From: Christian Araguas
Sent: Wednesday, November 12, 2008 3:16 PM
To: jtdavis@southernco.com
Cc: agaughtm@southernco.com; crpierce@southernco.com; wasparkm@southernco.com
Subject: Advanced Safety Evaluation Report on the VEGP ESP and LWA Part 3a/3
Attachments: Vogtle ESP Advanced SER Section 2.5.1.pdf

Subject: Advanced Safety Evaluation Report on the VEGP ESP and LWA Part 3a/3
Sent Date: 11/12/2008 3:15:31 PM
Received Date: 11/12/2008 3:15:00 PM
From: Christian Araguas

2.5 Geology, Seismology, and Geotechnical Engineering

2.5.1 Basic Geologic and Seismic Information

**Figure 2.5.1-8 - Location of the Pen Branch Fault
(Reproduced from SSAR Figure 2.5.1-34)**

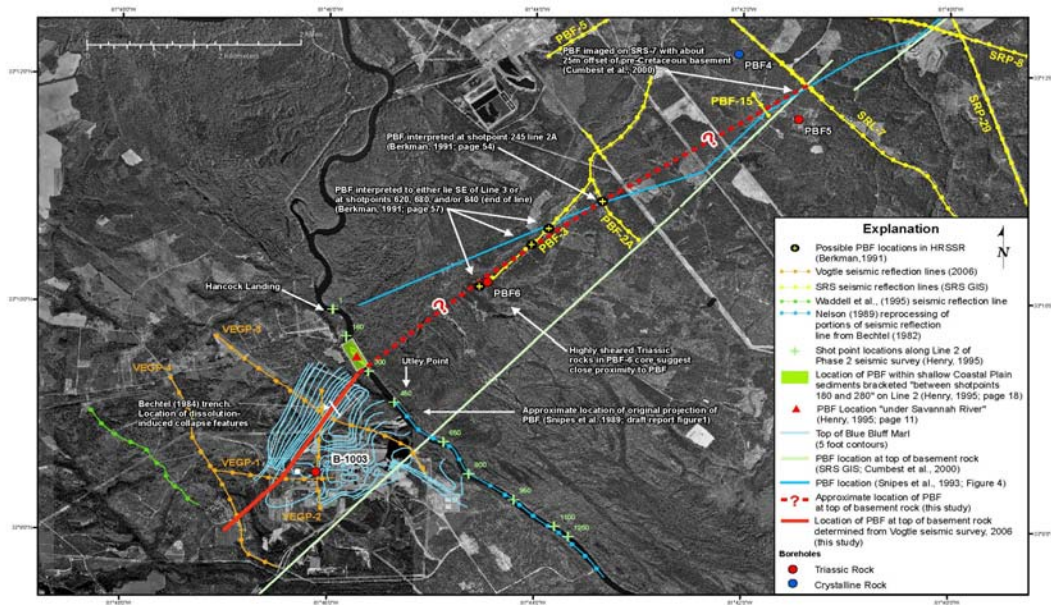
Regarding the Pen Branch fault, the applicant analyzed seismic reflection data collected for the ESP application to determine that the fault underlies the ESP site. The fault has also been imaged beneath the SRS on the eastern side of the Savannah River, although it shows no surface expression either at the SRS or the ESP site. Although evidence from stratigraphic data discussed by the applicant in the SSAR suggests that the last motion on the Pen Branch fault was pre-Eocene (greater than 33.7 mya) in age, the applicant understood the need to analyze this fault in more detail because of its location relative to the ESP site.

In RAI 2.5.1-1, the staff asked the applicant to indicate whether the fluvial terraces (Qty, Qtb, Qte, and Qto) are regional in extent or are local features uplifted by slip along the Pen Branch fault. In response, the applicant stated that the four abandoned terraces of the Savannah River extend well beyond the vicinity of the Pen Branch fault and are regional in extent. The four terraces extend for at least 33 km (20 mi) upstream and 29 km (18 mi) downstream (i.e., straight-line distances) from the VEGP ESP site. In addition, the applicant stated that the development of a sequence of laterally extensive fluvial terraces is characteristic of other major Piedmont-draining river systems as well as the Savannah River. In conclusion, the applicant stated, "The fact that the major fluvial terrace surfaces are correlative between major Piedmont-draining river systems suggests that these terraces form in parallel response to regional climatic and/or eustatic conditions, and are not the result of local tectonic perturbations."

In response to RAI 2.5.1-2, the applicant addressed whether the terrace elevation ranges suggested tilting or warping of terrace Qte by tectonic deformation along the Pen Branch fault and the implications of the 1 m (3 ft) limit of detection for deformation. The applicant concluded that variations in elevation of the Qte terrace surface are due largely to the eroded and dissected character of terrace Qte and not from warping or tilting of the terrace by Quaternary displacement on the Pen Branch fault. The applicant cited supporting evidence that these terrace surfaces clearly exhibit a range of surface elevations resulting directly from erosion and dissection which cannot be obviously equated with displacement along the Pen Branch fault. The applicant also concluded that the deformation detection limit of 1 m (3 ft) is an improvement over that attained in previous studies and consequently acceptable for assessing the possibility of Quaternary deformation of the terrace surface due to displacement along the Pen Branch fault. The applicant stated the following:

Based on an evaluation of the applicant's response, the staff concludes that, since the terraces are regional in extent, it is highly unlikely that they developed due to tectonic displacement along the Pen Branch fault. The trace of the fault is nearly perpendicular to the long axis of the terrace surfaces (see SSAR Figure 2.5.1-43), so the terraces are favorably oriented to register Quaternary deformation along the Pen Branch fault. Alternatively, the staff believes a more likely origin for the terraces involves regional changes in sea level relative to the continental land mass. These regional changes resulted from either climatic, isostatic, or eustatic effects or some combination of these nontectonic mechanisms. Climatic, isostatic, and eustatic perturbations alter sea level relative to the land mass on a regional scale, either by raising the sea level itself (climatic and eustatic changes) or isostatically uplifting blocks of continental crust due to regional crustal unloading (isostatic changes). The mechanism of tectonic perturbations is separate and distinct from these regional changes in sea level and would involve tectonic uplift (e.g., fault displacement) to raise a fault block and produce abandoned fluvial terraces atop that block. The staff's conclusion that the fluvial terraces developed as a result of nontectonic processes rather than by tectonic uplift is based on the staff's evaluation of the applicant's response to RAI 2.5.1-1, and subsequent RAI responses pertaining to the same subject (i.e., RAI 2.5.1-2 and RAI 2.5.1-3).

The discontinuous Qty terrace surface of late Pleistocene to possibly Holocene age does not provide constraints for evaluating the potential for Quaternary displacement on the Pen Branch fault. The significantly older and more laterally continuous remnants of the 350 ka to 1 Ma (Geomatrix, 1993) Ellenton terrace (Qte) provide a more robust datum to evaluate potential tectonic deformation on the Pen Branch fault.

After review of the applicant's response to RAI 2.5.1-3, as well as geologic field maps of the area, the staff concurs with the applicant's conclusions that terrace Qty is too discontinuous to be a suitable strain marker for deformation of the terrace surface or the underlying strata. Furthermore, the terrace extends beyond the location of the Pen Branch fault. The staff also agrees with the applicant that terrace Qte provides a much more robust indicator for potential Quaternary displacement of the underlying Pen Branch fault than terrace Qty.
